# Technical Note

<b>Project</b>	Plots 23-26, The Oxford Science Park	<b>Project No</b>	13886
<b>Subject</b>	Section 73-Undercroft Amendments	<b>Date</b>	6 December 2023
<b>File Ref</b>	13886-CRH-ZZ-XX-TN-C-0004-P1_TN-Undercroft Removal.docx	<b>Pages</b>	10

This Technical Note has been prepared in support of a Section 73 amendment application and discharge of condition application to Plots 23-26 of Oxford Science Park to discuss changes made to the undercroft across the proposed development and the impact this change has on both the proposed site surface water drainage strategy and flood risk. The original planning application was submitted to Oxford City Council in September 2022 ref. 22/02168/FUL

Drawing Title  
 PROPOSED SITE PLAN SKETCH FOR NMA

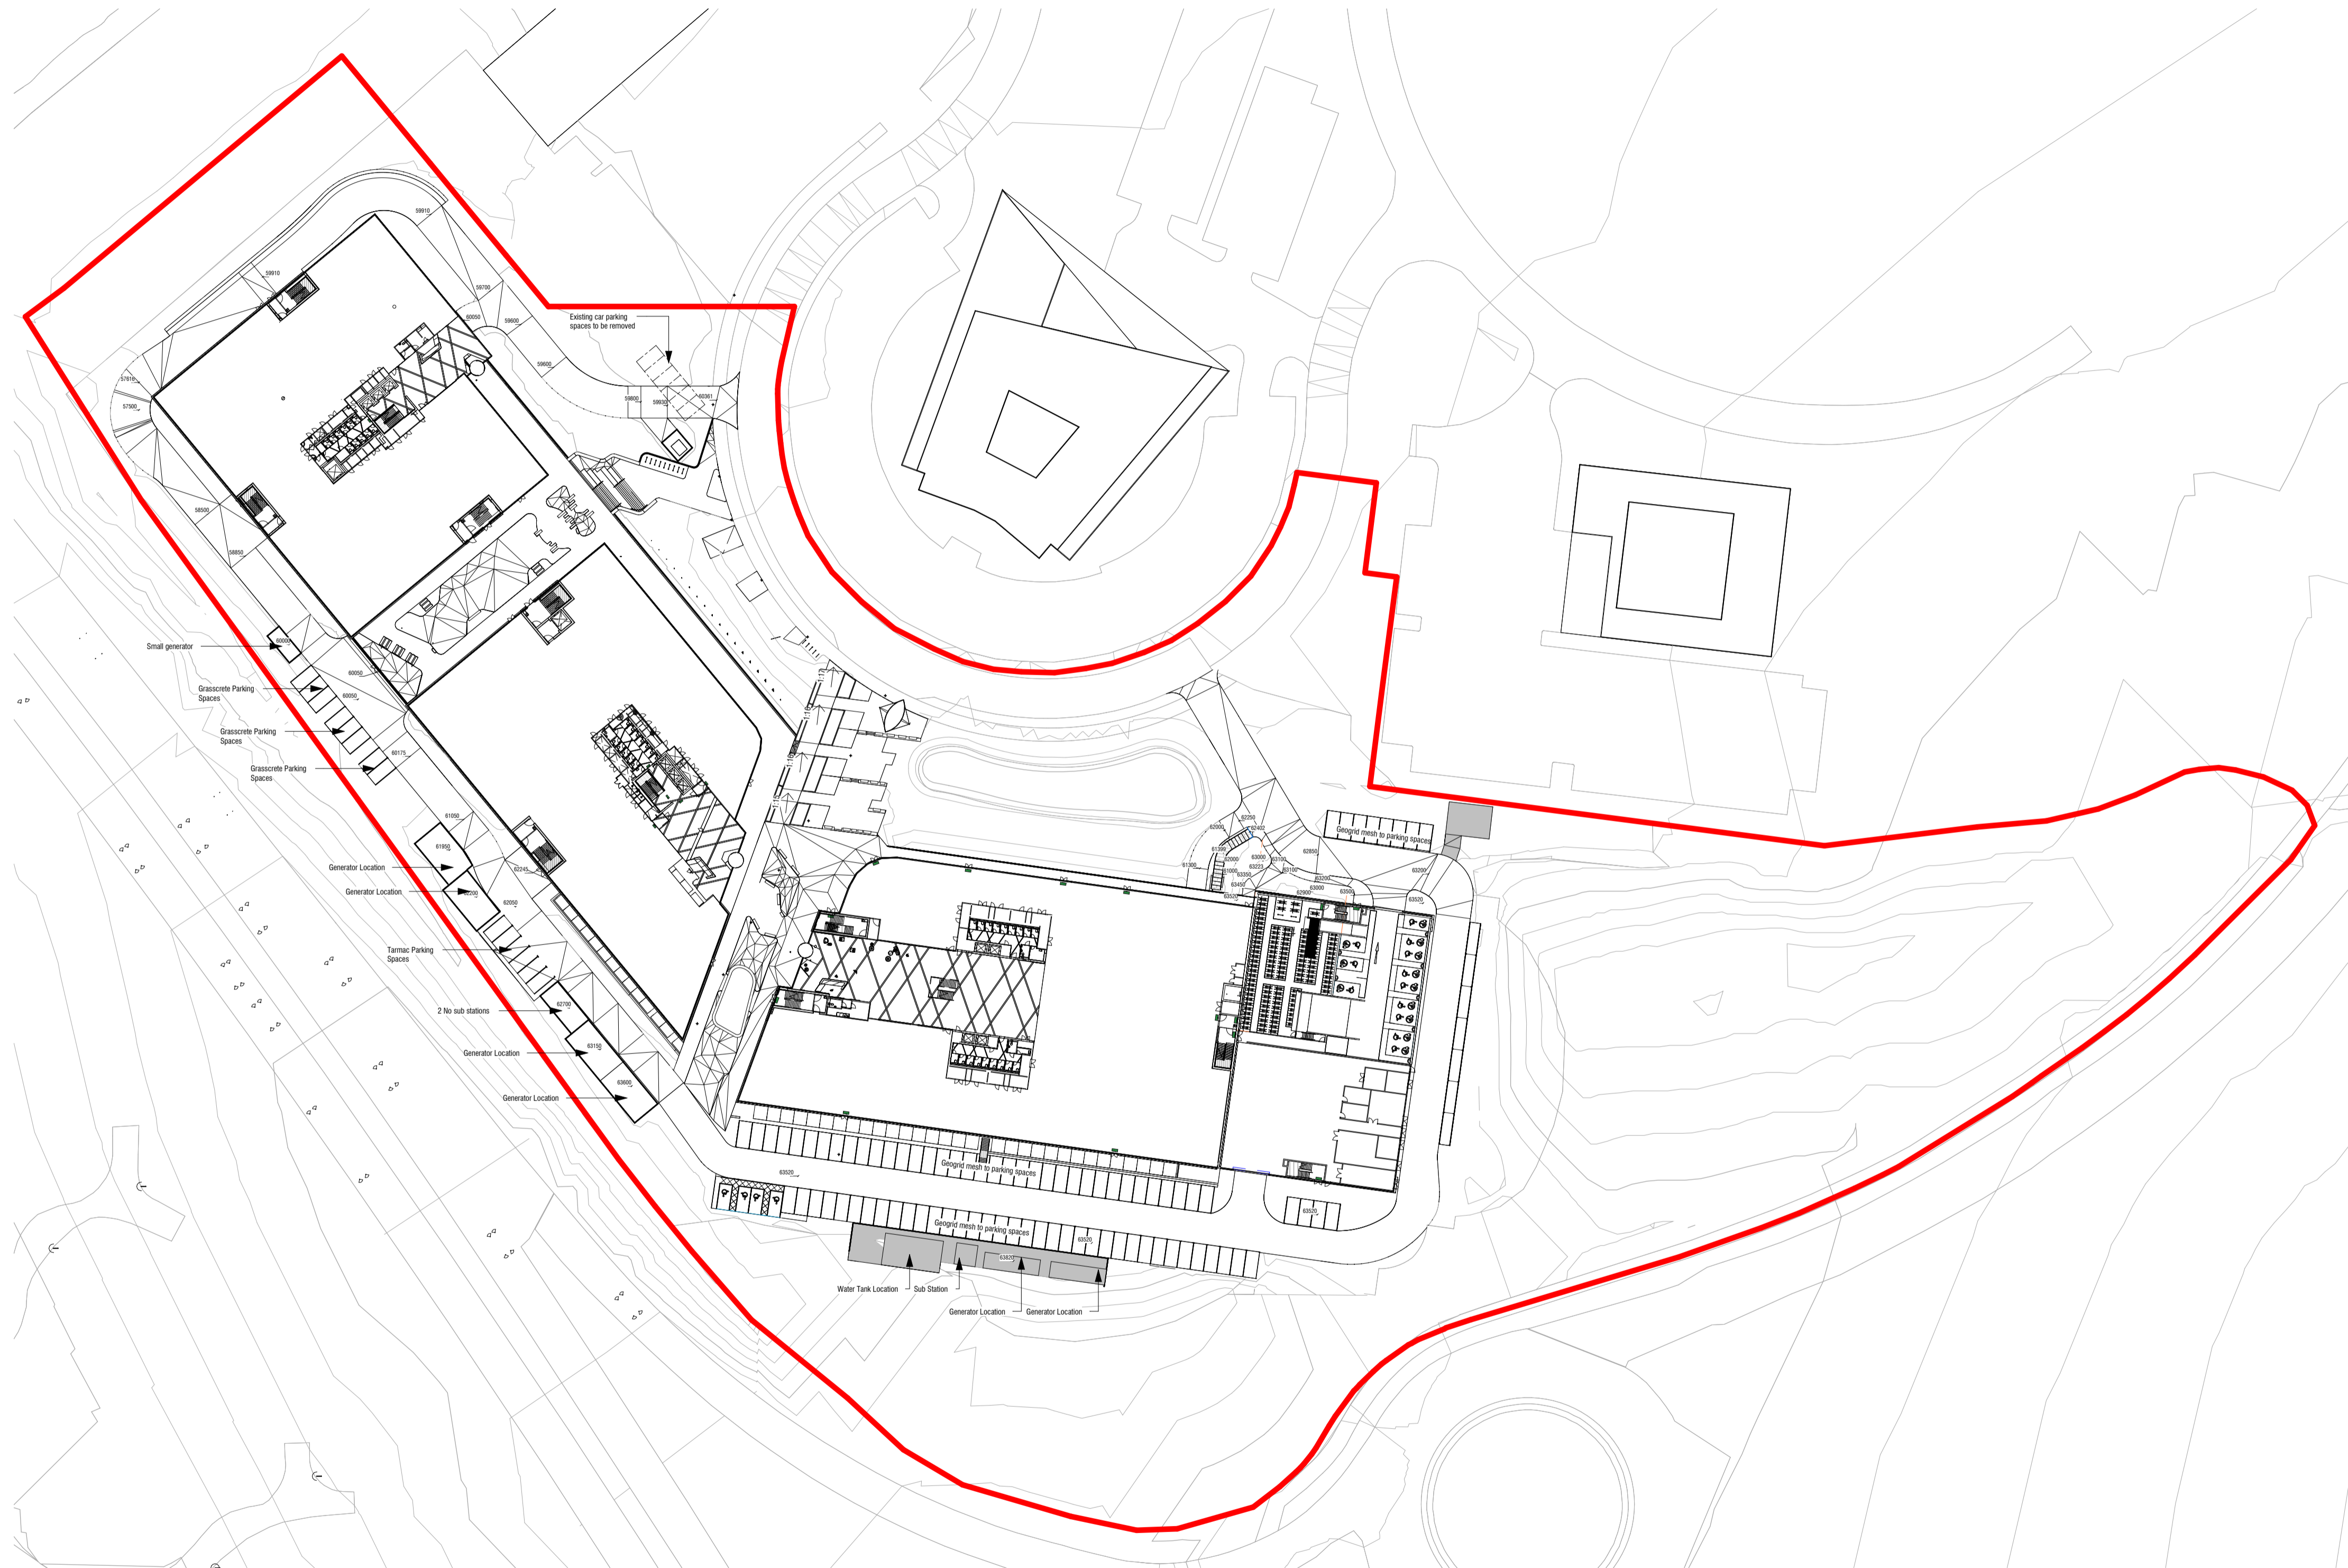
During design development of the scheme, extensive detailed analysis of ground water levels has been undertaken on site and have concluded that the water table levels are higher than was understood at planning application stage. This has identified the need to apply for an abstraction license from the Environment Agency which can take circa 12 months. These timescales would cause unacceptable delay to the project. As a result of this the lower level of undercroft car parking (FFL 57.500) has been removed from the scheme. This resulted in a shortfall of car parking spaces which needed to be provided elsewhere. To resolve this issue the decision was taken to extend the upper undercroft level beneath Building 3. As a result, the scheme now comprises of 1 level of undercroft car parking which now extends beneath all three buildings. The finished floor level of the undercroft is now set at 60.050mAOD. The updated site masterplan is attached at Appendix 1 for reference.

**Proposed Drainage Layout**  
Sheet 1 of 4

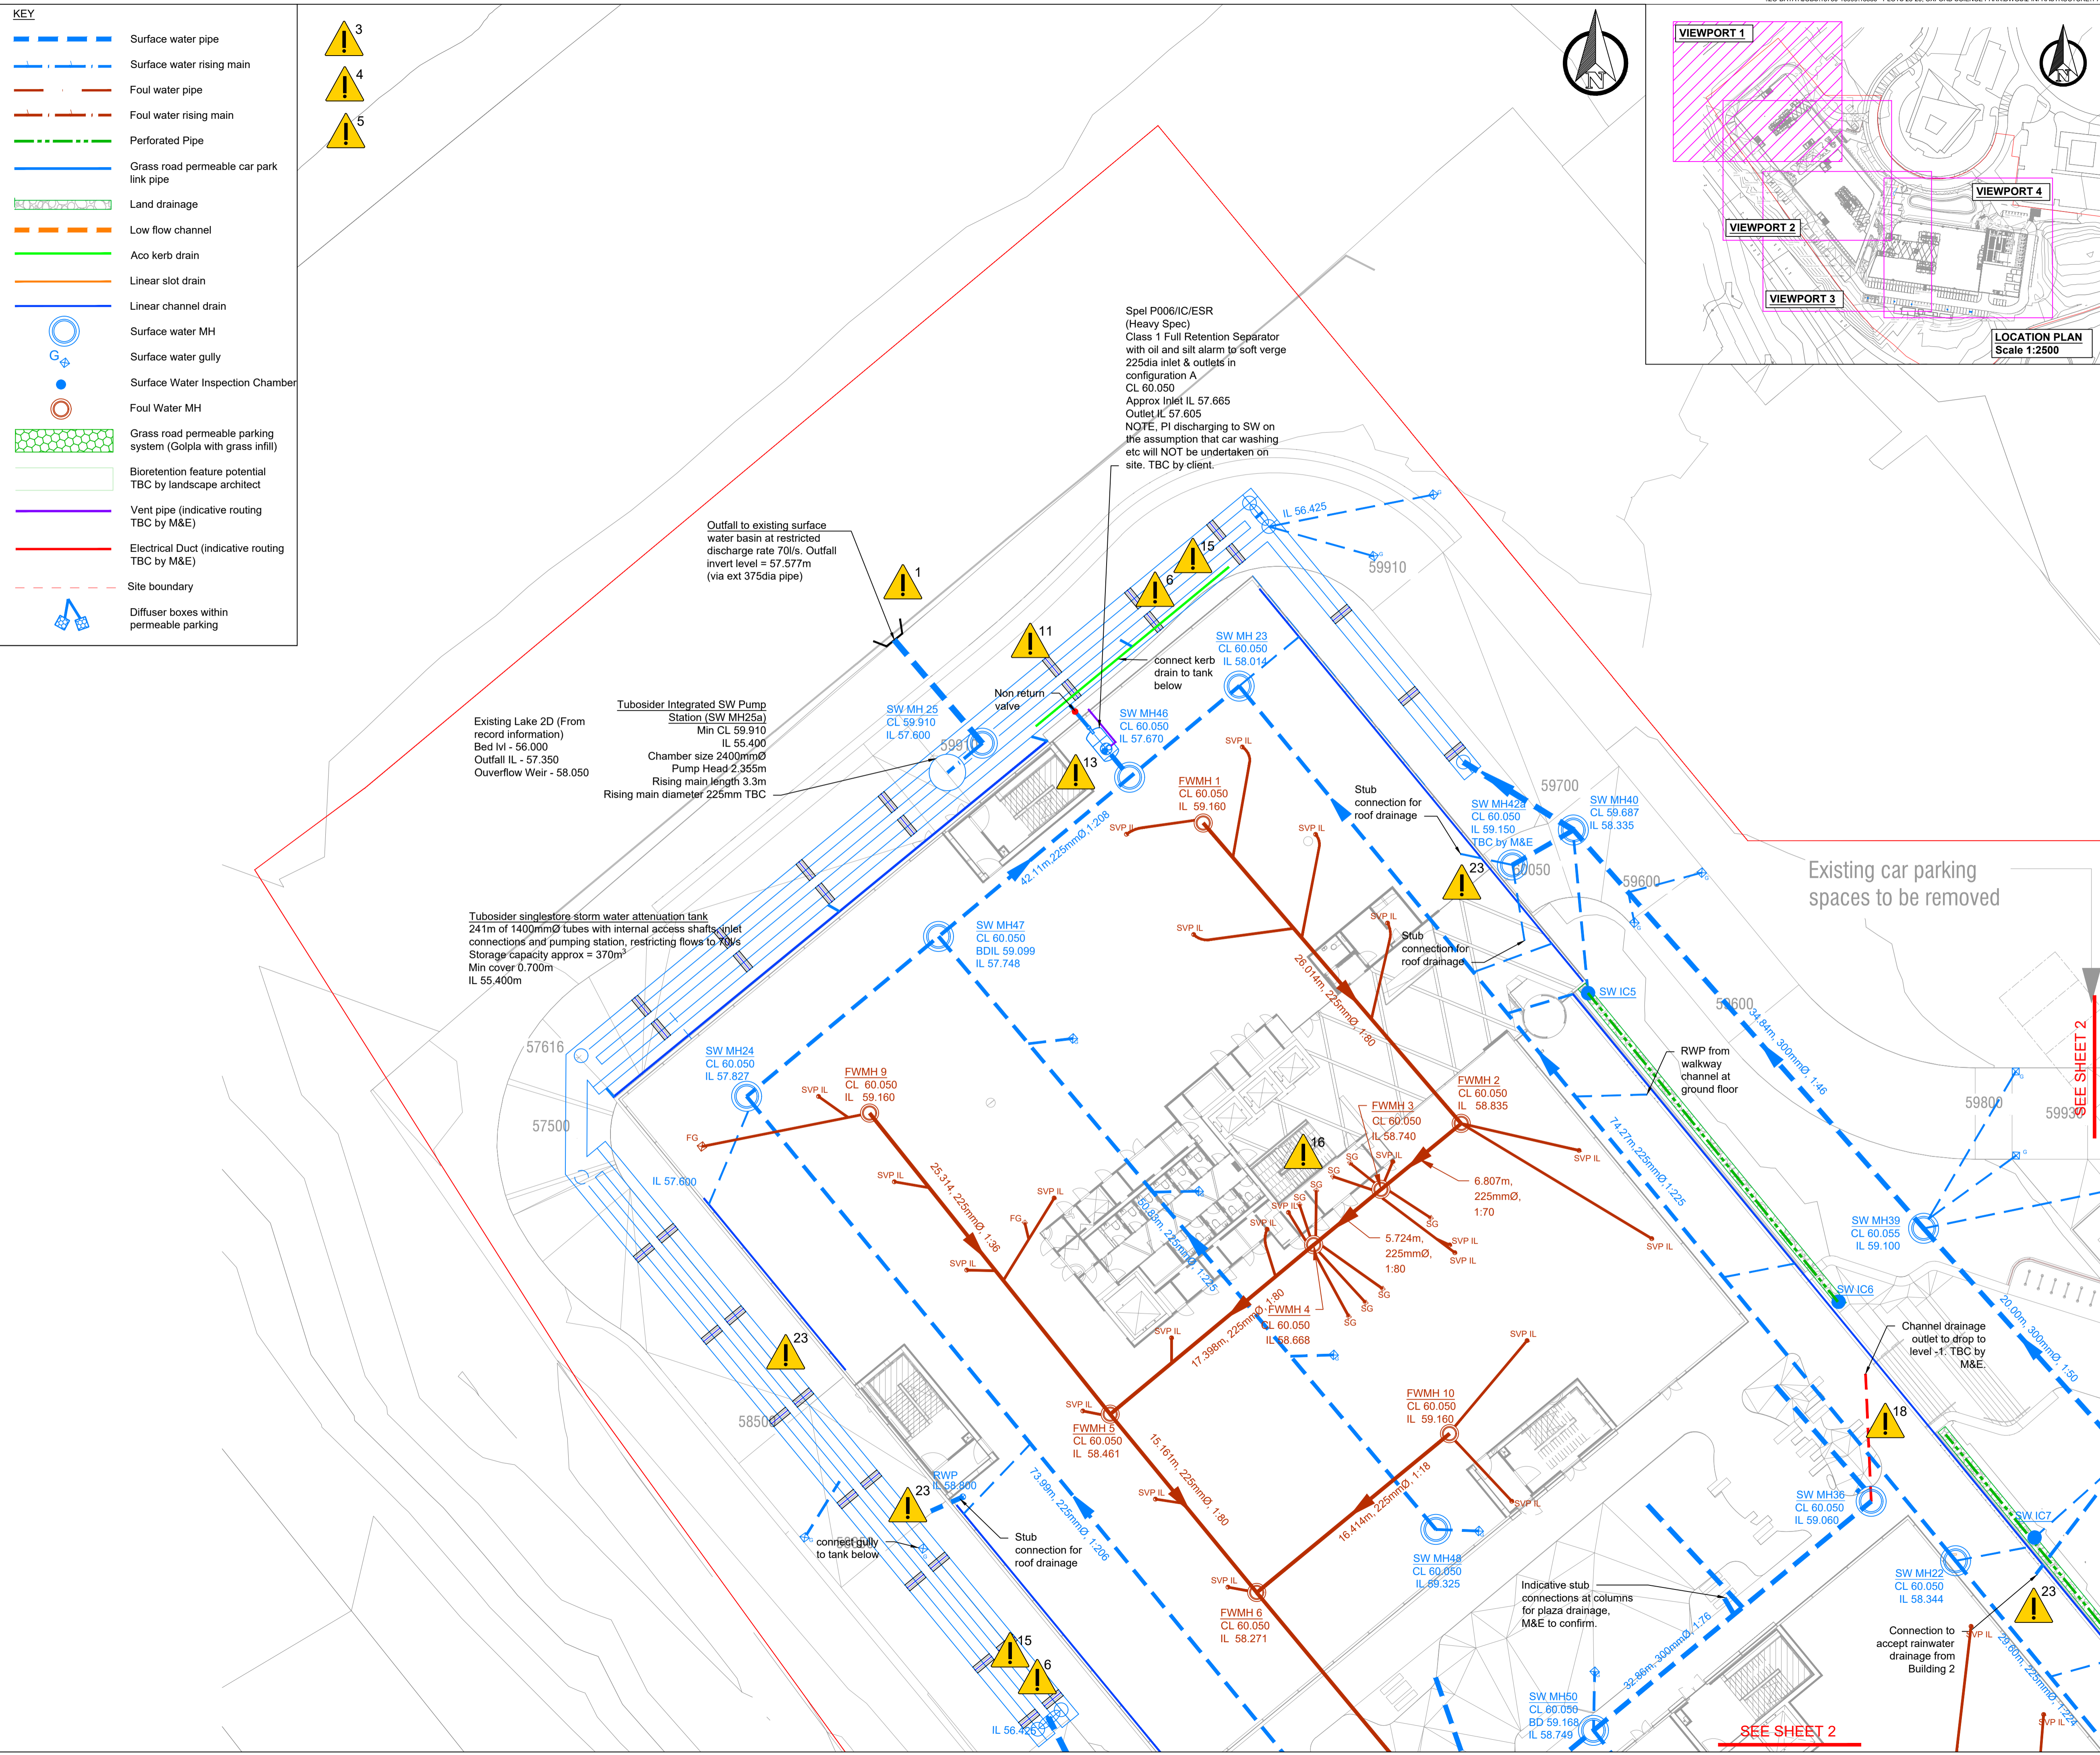
As the foul drainage system relies on a pumped connection to the existing private foul drainage system the changes required were minimal and predominantly comprised minor amendments to the main drainage runs along with the realignment of the foul branch connections to align with the updated pop-up locations. Therefore, it can be concluded that the FW drainage strategy remains unchanged and aligns with what was set out in the approved flood risk assessment for the site ref. 13886-CRH-ZZ-XX-RP-C-0002-P2.

Changes to the surface water drainage system are also minimal as the changes to the scheme associated with the undercroft amendments do not affect the proposed surface water catchment areas and discharge locations. For full details of the site surface water drainage strategy along with catchment splits and discharge rates into the wider site drainage system please refer to the following approved documents:

- 13886-CRH-ZZ-XX-DR-C-5057-P1-Proposed Drainage Strategy
- 13886-CRH-ZZ-XX-DR-C-5058-P1-Proposed Drainage Strategy
- 13886-CRH-ZZ-XX-DR-C-5059-P1-Proposed Drainage Strategy
- 13886-CRH-ZZ-XX-DR-C-5060-P1-Proposed Drainage Strategy
- 13886-CRH-ZZ-XX-DR-C-5400\_P2 RPZ Overlaid on Drainage Layout (Sheet 1 of 2)
- 13886-CRH-ZZ-XX-DR-C-5401\_P2 RPZ Overlaid on Drainage Layout (Sheet 2 of 2)
